Item Name: Crosstube Fwd

DART AEROSPACE LTD		Work Order:	77415
Description: Crosstube High Fwd (205/212/412)		Part Number:	D212-664-101
Inspection Dwg: D212-664-141 Rev: D		Page 1 of 1

DRAWING NO. D212-664-141	TITLE XTUBE ASSY (205/212/412 HI FWD)	REV. D	DART AEROSPACE LTD ENGINEERING ORDER		D.E.O. NO. D212-664-141-D-1	SHEET NO. SHEET 1 OF 2	SCALE NTS
DRAWN	CHECKED	UP	MFG. APPR.	ER	APPROVED	MP	DE APPR.
DATE 11.04.07	DATE 11.07.11		DATE 11.04.12		DATE 11/04/12		DATE 11.04.12

DRAWING NO. D212-664-141	TITLE CROSSTUBE ASS'Y (205 HI FWD)	REV. D	DART AEROSPACE LTD ENGINEERING ORDER	D.E.O. NO. D212-664-141-D-2	SHEET NO. SHEET 1 OF 1	SCALE NTS
DRAWN <i>UP</i>	CHECKED <i>ASS</i>	MFG. APPR. <i>AB</i>	APPROVED <i>MD</i>	DE APPR. <i>TH</i>		
DATE 11.07.15	DATE 11.07.20	DATE 11.07.21	DATE 11/07/21	DATE 11.07.21

**D212-664-141/-141B
ASSEMBLY DETAIL**

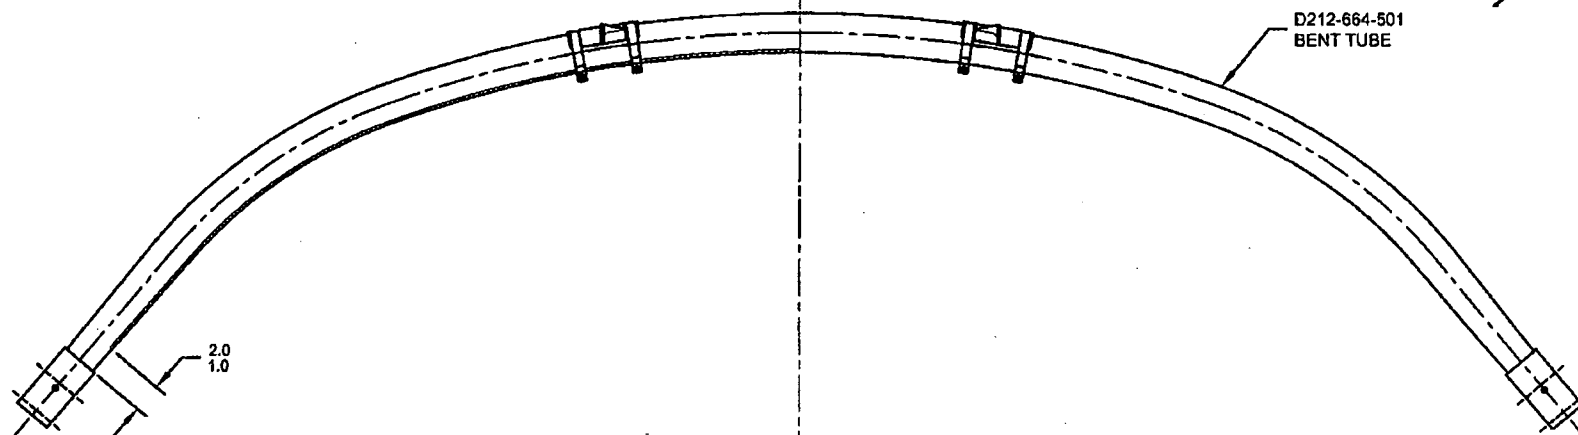
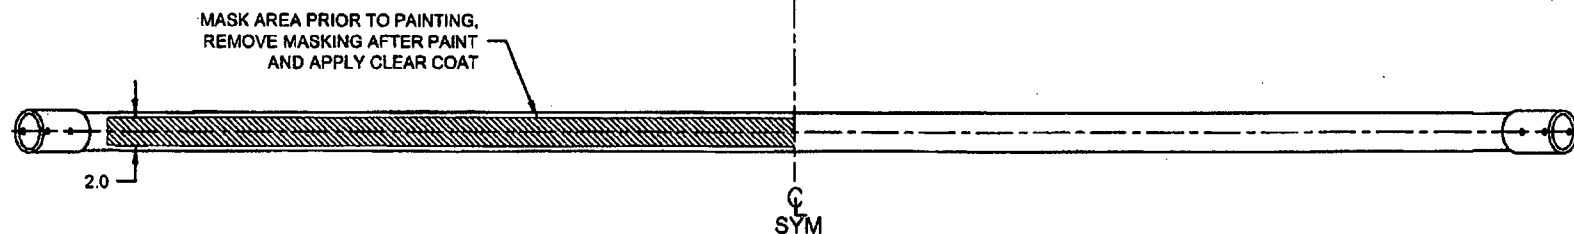
ADD AN INSPECTION WINDOW TO UNDERSIDE OF CROSSTUBE.

- 2) FINISH: CHEMICAL CONVERSION COAT PER DART QSI 005 4.1
PRIME INSIDE AND OUTSIDE PER DART QSI 005 4.2
MASK UNDERSIDE OF CROSSTUBE AS SHOWN (HATCHED AREA) AND
PAINT OUTSIDE PER DART QSI 005 4.2
REMOVE MASKING AND APPLY CLEAR COAT
